TRAFFIC IMPACT STUDY

**PROPOSED SPEEDWAY
DEVELOPMENT**

**Located at
Northwest corner
Of
U.S. 23 and Hills-Miller Road
City of Delaware, Ohio**

**Prepared by:
CESO, Inc.
8534 Yankee Street
Dayton, OH 45458**

PROPOSED US 23 NORTH SIDE WIDENING
HILLS MILLER RD. & US 23

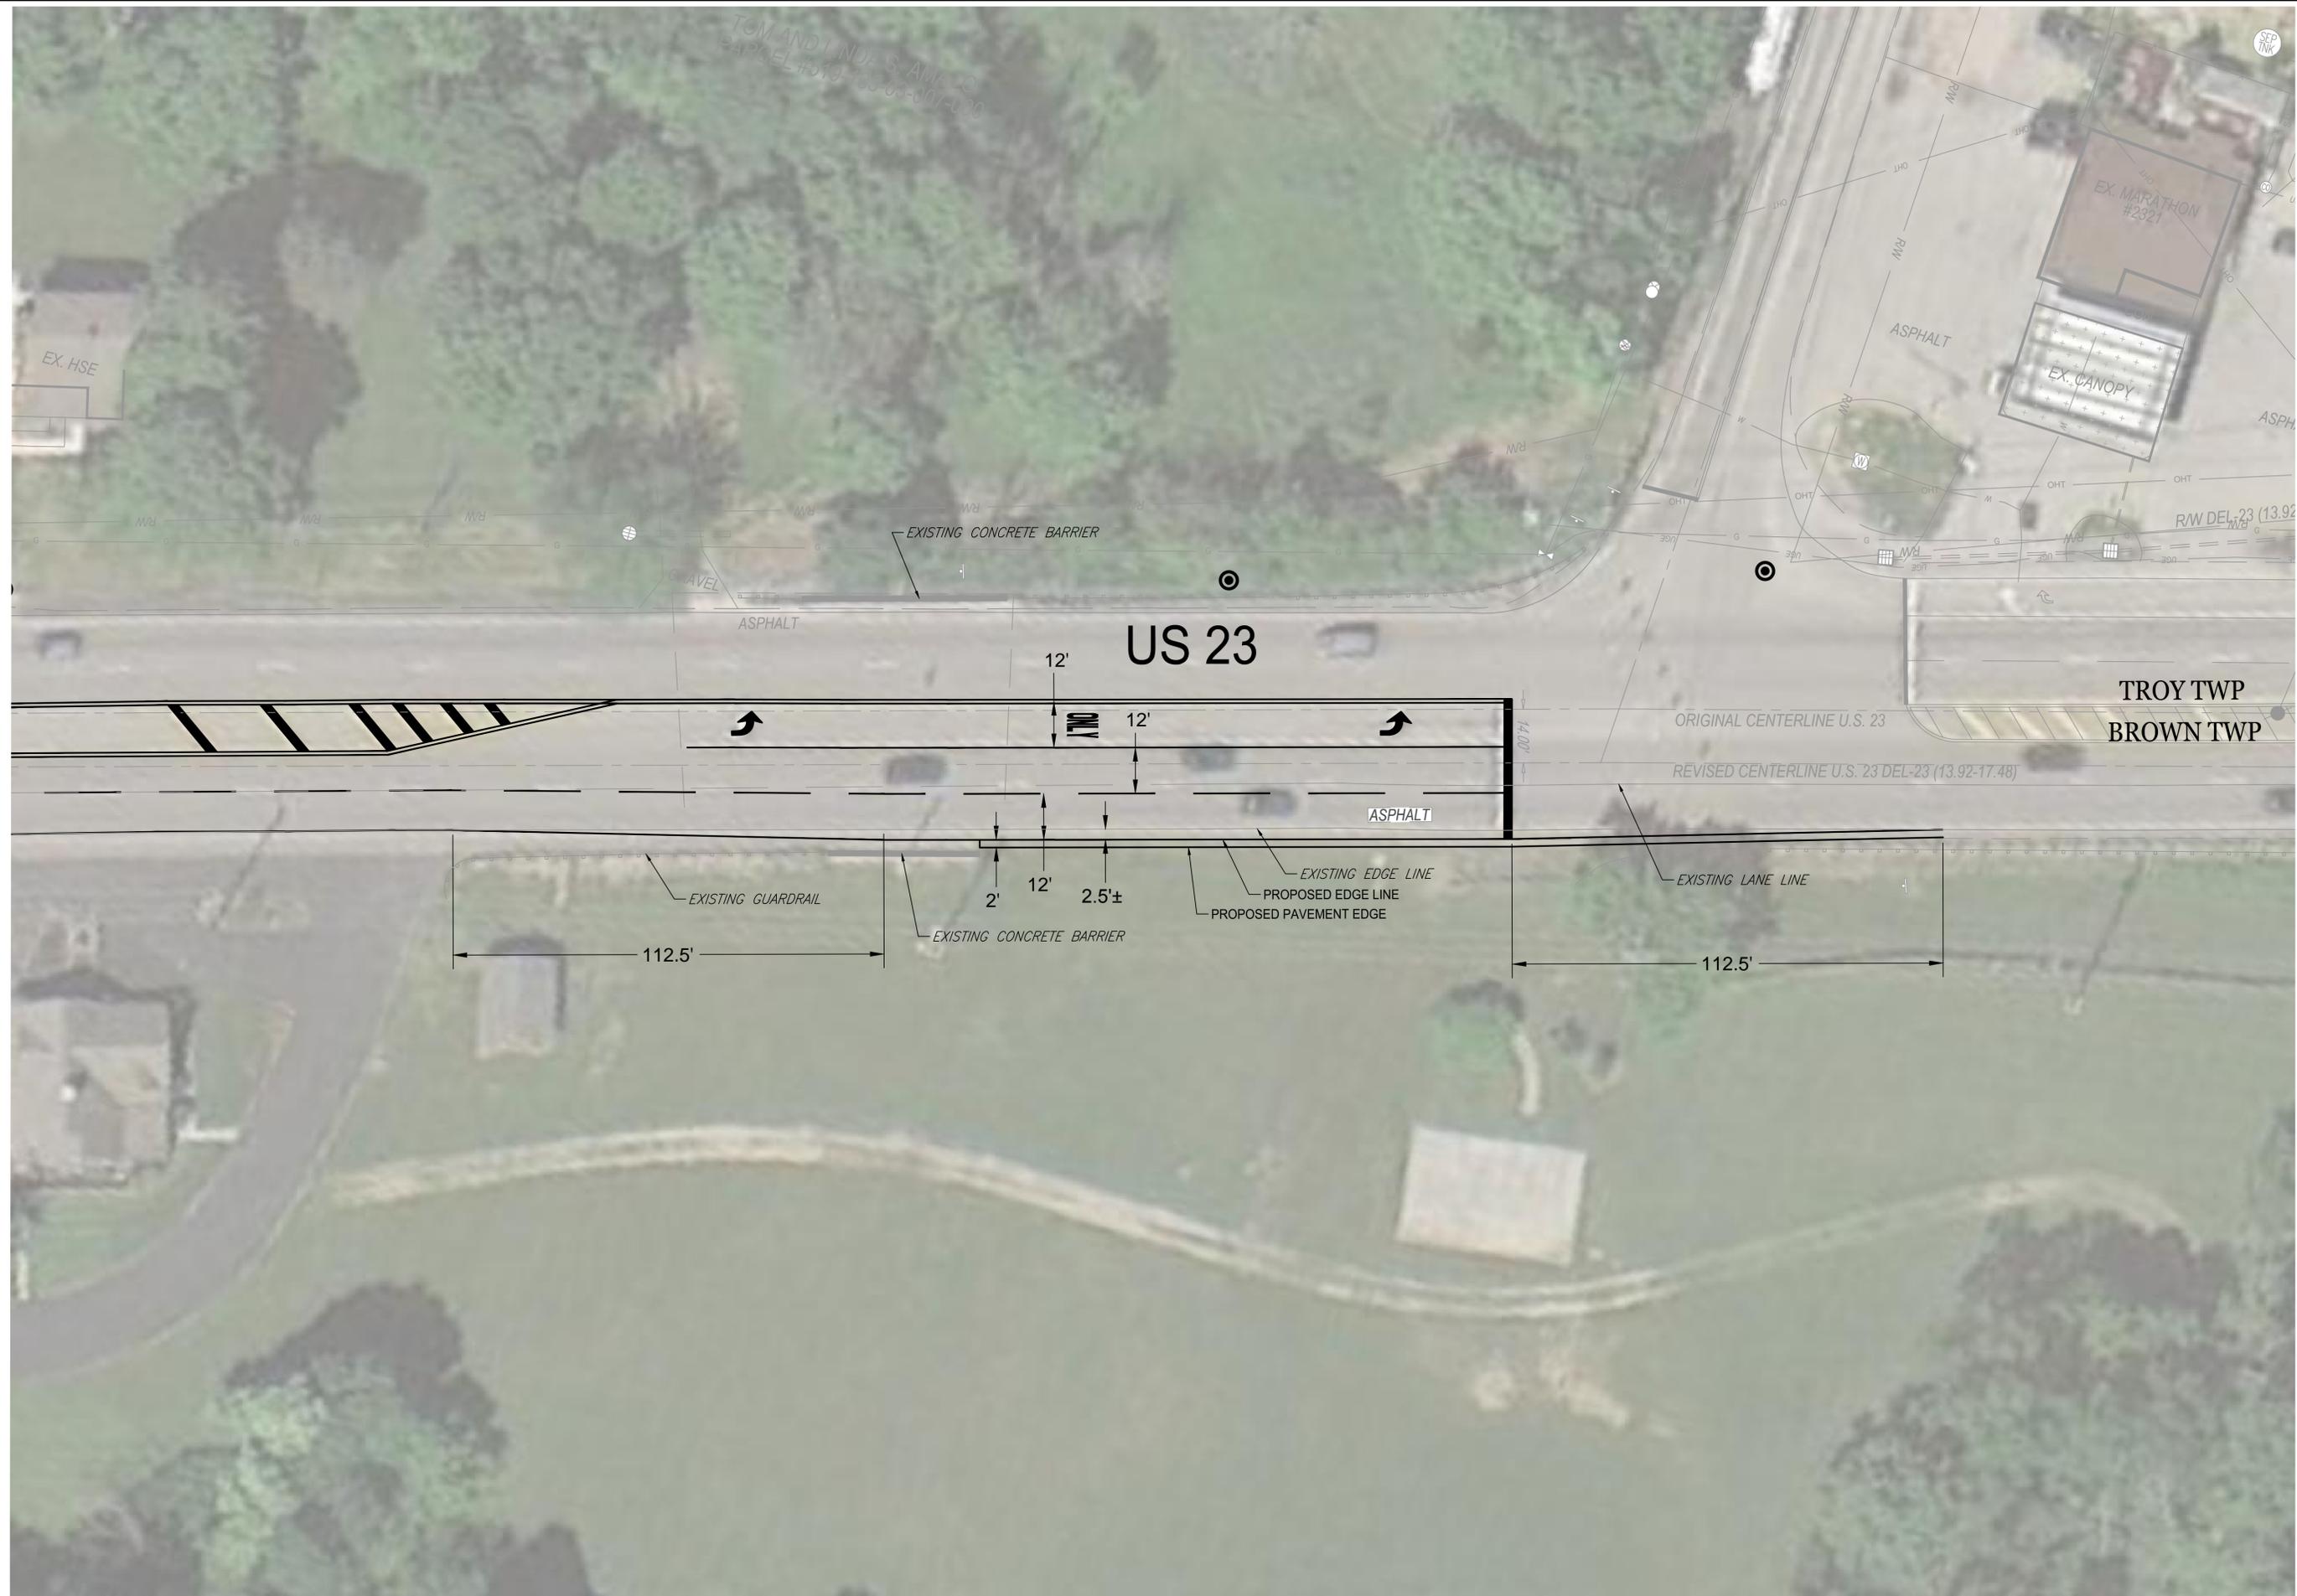
- In our response letter dated October 16, 2014, comment #2 under site configuration comments was as follows: *As we previously discussed and based on the above comments and revisions, the pavement width on Hills Miller from US 23 to the access drive will need to be widened to create a three lane section (12' lane width) in order to provide for both an eastbound left and right turn lane at the US23-Hills Miller Intersection.*

Your response letter stated that an eastbound left was recommended in the report but did not address the three lane full widening. The city wishes to restate the initial requirement of a full three lane section that will extend from US 23 to the site entrance. This will be a requirement for approval. We will not, however, require a taper to the west of the site access at this time. A tapered section will be a requirement of future development to the north or west. Tapering for these improvements can be accomplished through striping.

- The taper from the widened section of pavement to existing lanes is shown through the intersection. The design must be revised to show the taper occurring north of the intersection.

- A resurfacing or microsurfacing of the areas to be striped shall be included in the budget as grinding existing pavement markings is not an acceptable method of removal.
- Appropriately designed radii are to be incorporated into the intersection design.

RESPONSE: Traffic study has been revised to state that the City of Delaware requires for Hills-Miller road to be widened from the western property line of the Speedway parcel to U.S. 23 creating a three lane section with 12' lane widths.

RESPONSE: Traffic study has been revised to state that the City of Delaware requires that U.S. 23 northbound be widened in order to accommodate a 12' northbound left turn lane to meet current ODOT standards. The remaining comments are to be addressed in the roadway design portion of the project.
